**MONTGOMERY COUNTY HISTORIC PRESERVATION COMMISSION**  
**STAFF REPORT**

<b>Address:</b>	9912 Capitol View Ave., Silver Spring	<b>Meeting Date:</b>	2/25/2026
<b>Resource:</b>	1935+ (Nominal) Capitol View Park Historic District	<b>Report Date:</b>	2/18/2026
<b>Applicant:</b>	Russell Gossett	<b>Public Notice:</b>	2/11/2026
<b>Review:</b>	HAWP	<b>Tax Credit:</b>	No
<b>Case No.:</b>	1147866	<b>Staff:</b>	Devon Murtha
<b>PROPOSAL:</b>	Deck demolition, new rear construction, new deck construction, and new patio

PROPOSED ELEVATIONS

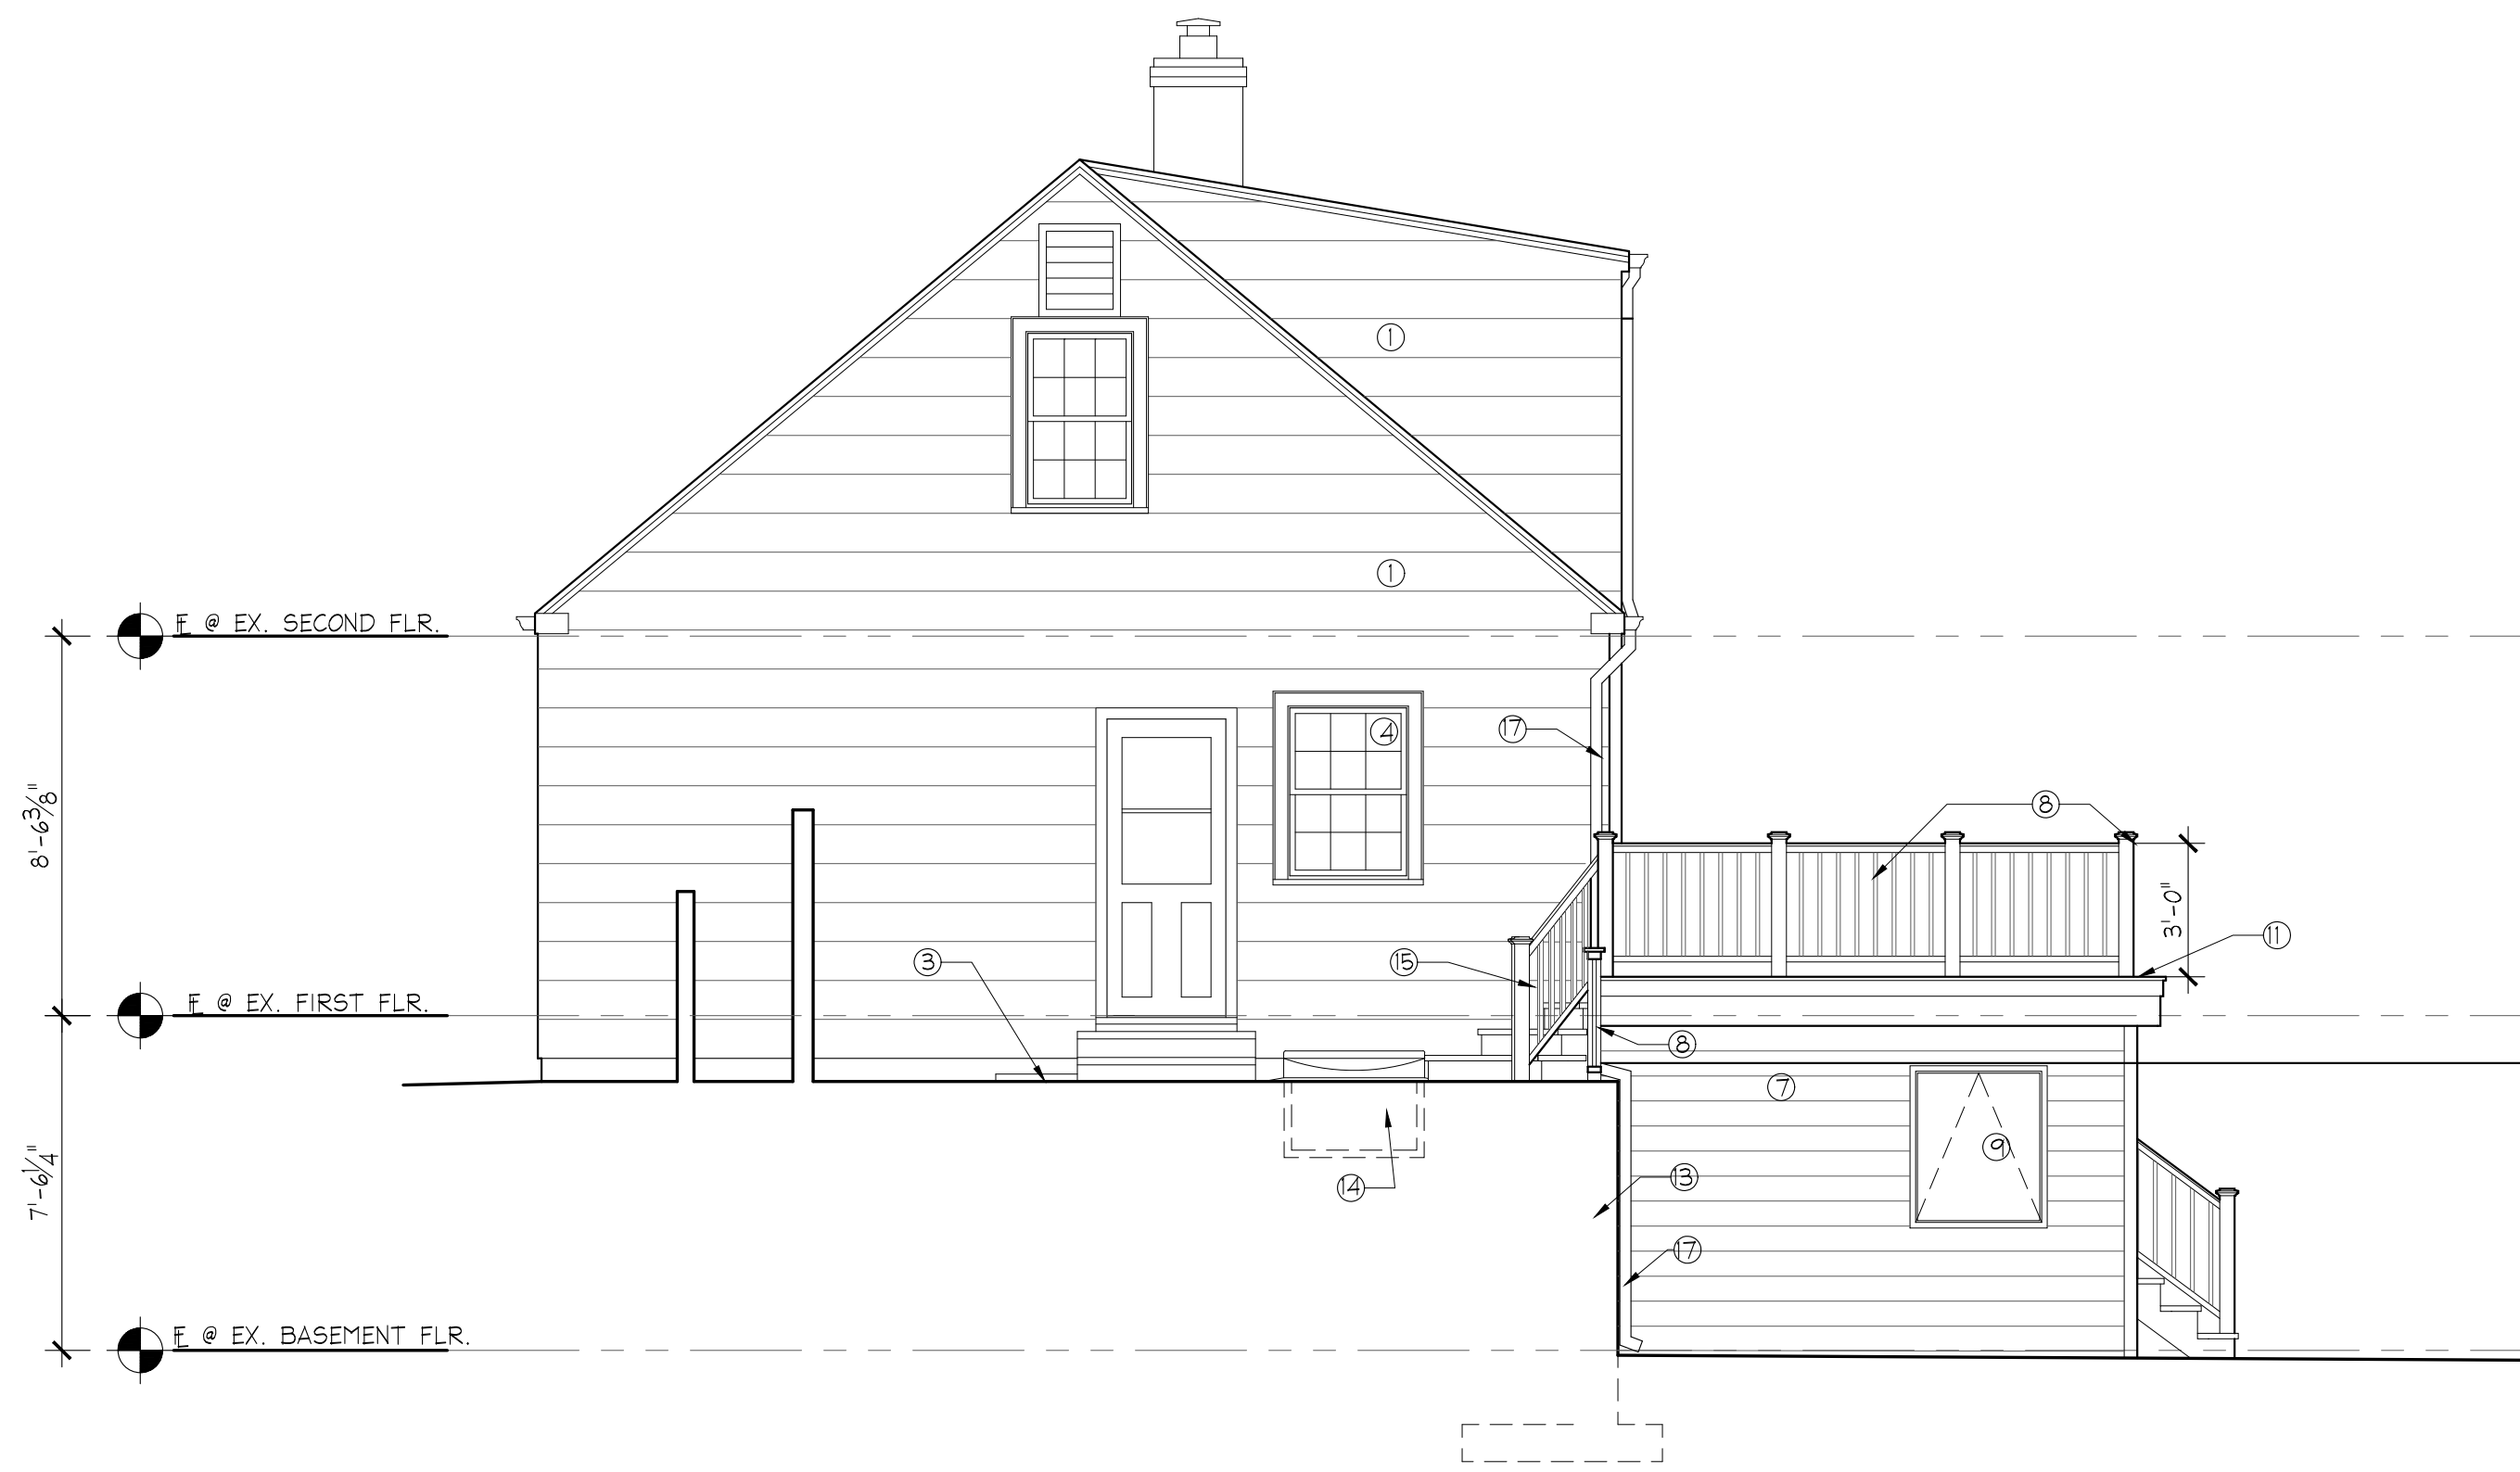
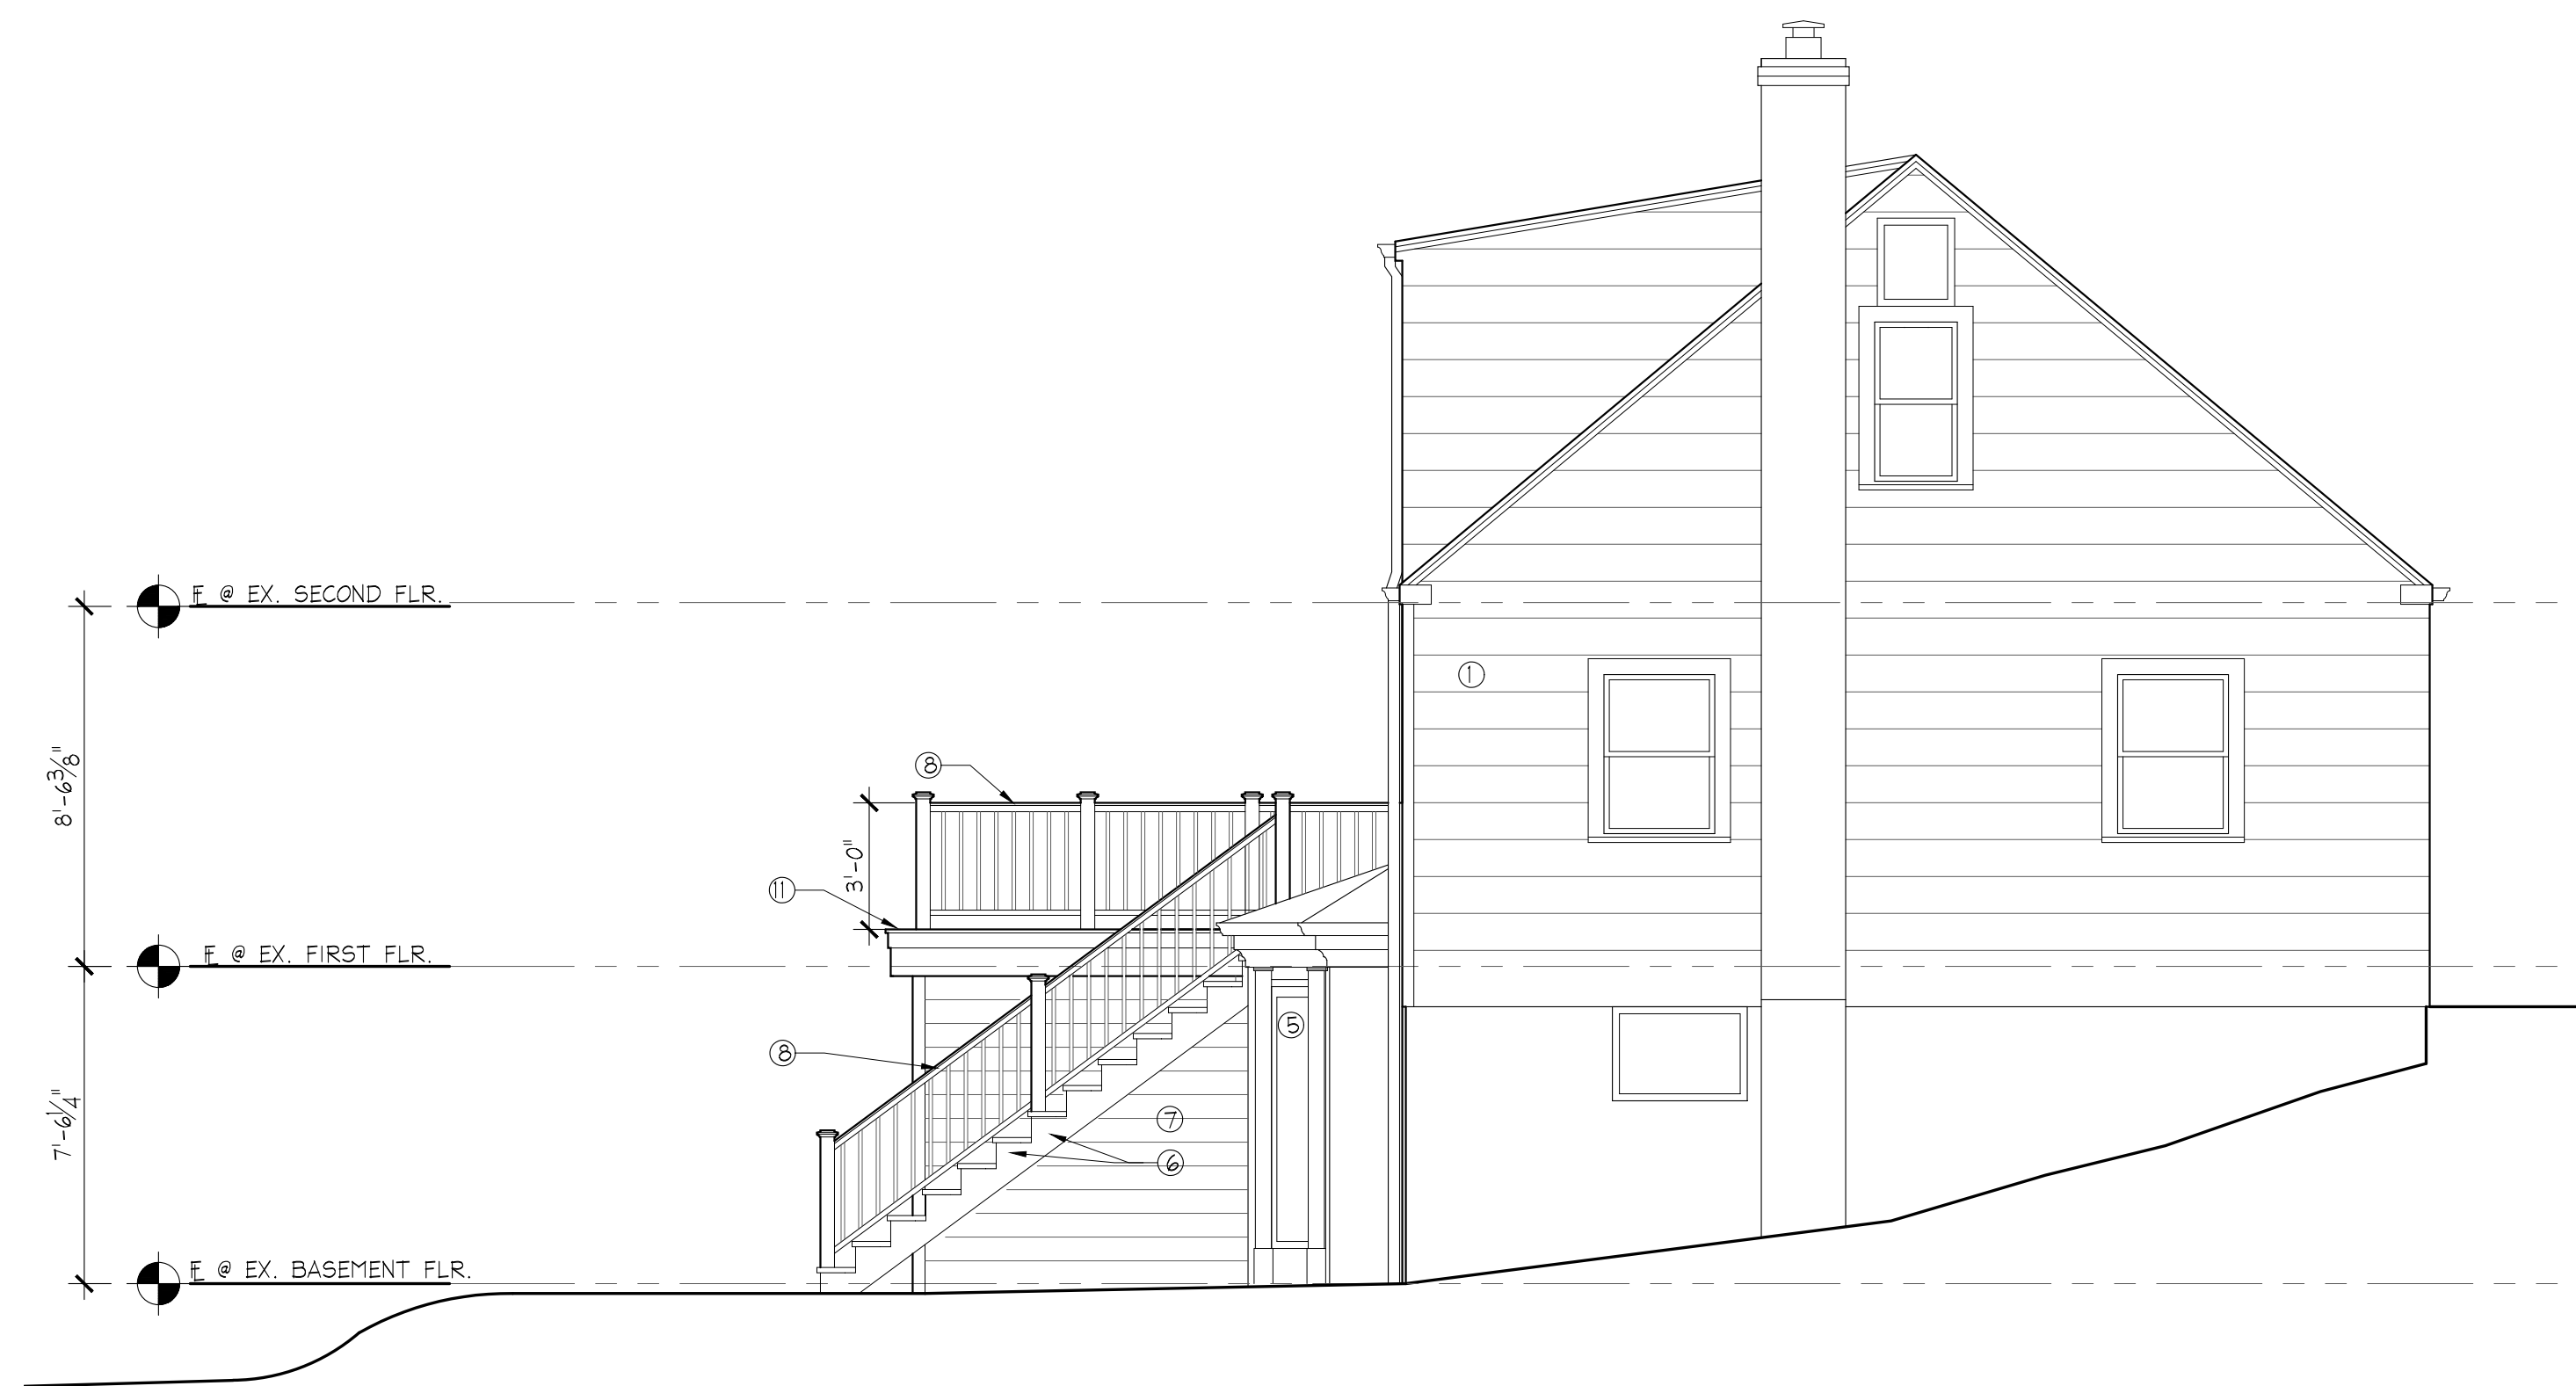
1. The fiber cement board must be installed with a smooth finish, not a faux wood grain. Updated specifications must be provided to Staff to verify the condition prior to final approval of the HAWP

Staff finds that the proposed materials are generally in keeping with the character of the resource and will not be visible from the right-of-way. Per *Policy No. 24-01*, the deck flooring does not need to meet the qualifications of compatible substitute material. Although Staff finds no issue with installation of fiber cement siding; however, Staff believes that the faux wood grain texture, is not appropriate. The proposed exaggerated faux wood grain pattern does not match the texture of traditional, painted wood siding. In the Capitol View Park Historic District, the HPC has typically approved fiber cement plank board siding with a smooth finish.

1. The fiber cement board must be installed with a smooth finish, not a faux wood grain. Updated specifications must be provided to Staff to verify the condition prior to final approval of the HAWP
